# Memorandum

| <b>Subject</b>      | 1919 Maple Grove Road - Transportation Impact Assessment -<br>Addendum 1   |                   |                |

## Step 4 Submission (Analysis) – Circulation Comments & Response

Figure 1 – Proposed 1919 Maple Grove Phasing

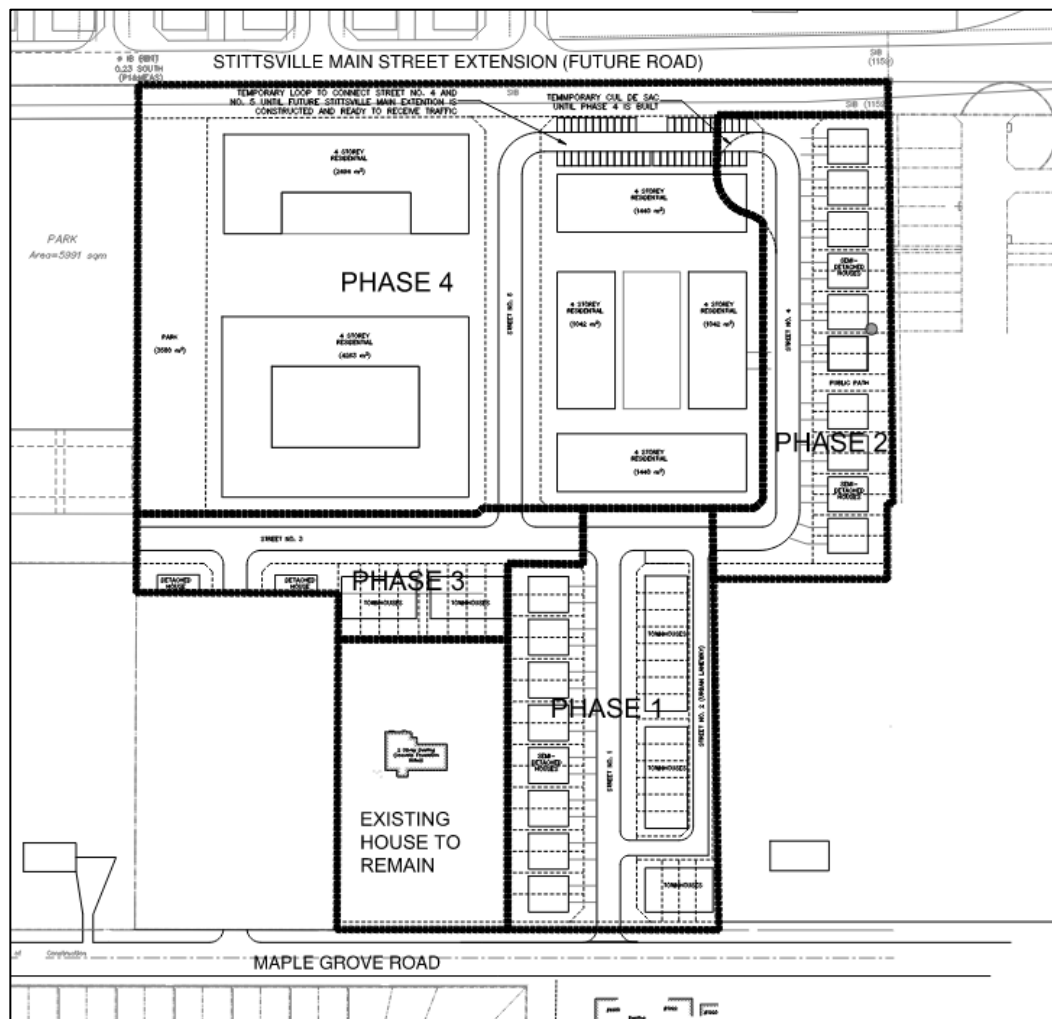
- The phasing for the subject site is now expected to occur over a 10-year period as opposed to the more conservative 5 years assumed in the TIA, as shown in **Figure 1**; and
- Site access connections to the north will only be established once the Stittsville Main Street Extension is fully implemented, which will help to mitigate the potential for cut-through traffic within the subject site. In the interim, either temporary turning circles or a connection 'loop' between Streets 4 and 5 will help facilitate site circulation in the final phases of development prior to the connection of these streets to Stittsville Main Street.

**A-001**

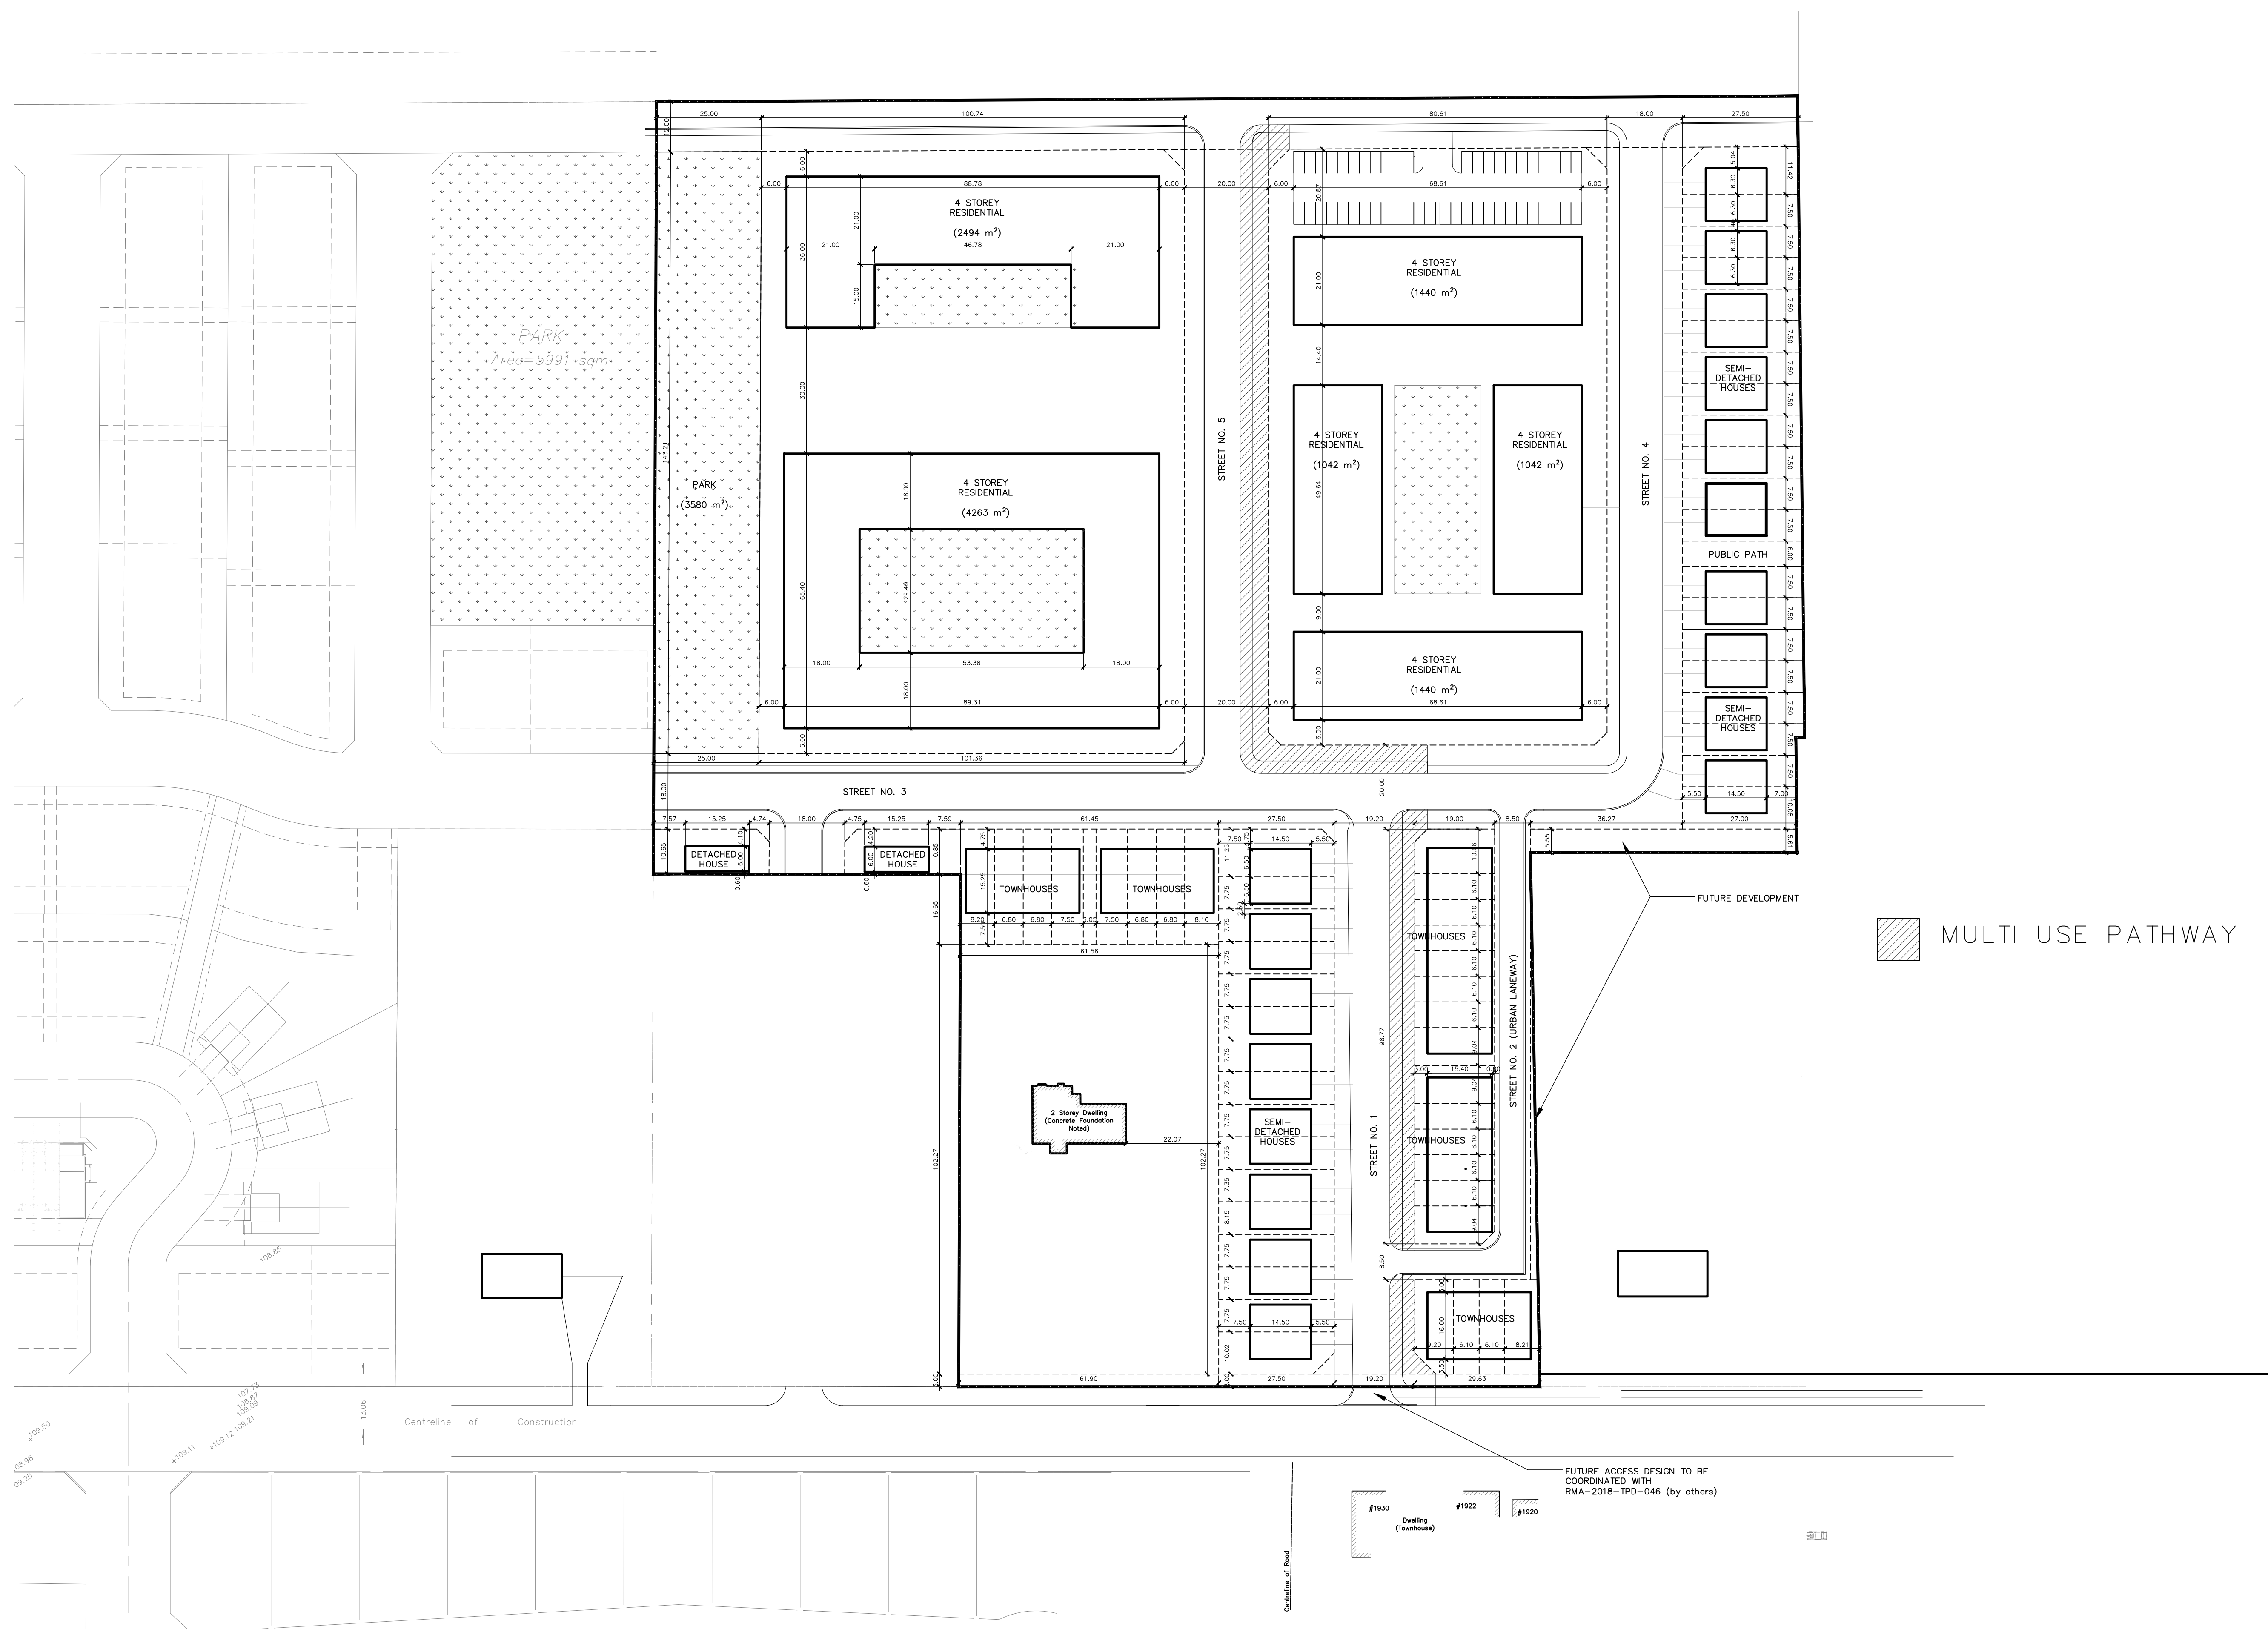
4. PM&S: indicate on the drawing at the access to MG that the design and PM&S to be constructed as per RMA form 1981 MG.

➤ **IBI Response: Acknowledged. A note has been added to the site plan, indicating "Future access design to be coordinated with RMA-2018-TPD-046 (by others)".**

FUTURE ACCESS DESIGN TO BE COORDINATED WITH RMA-2018-TPD-046 (by others)
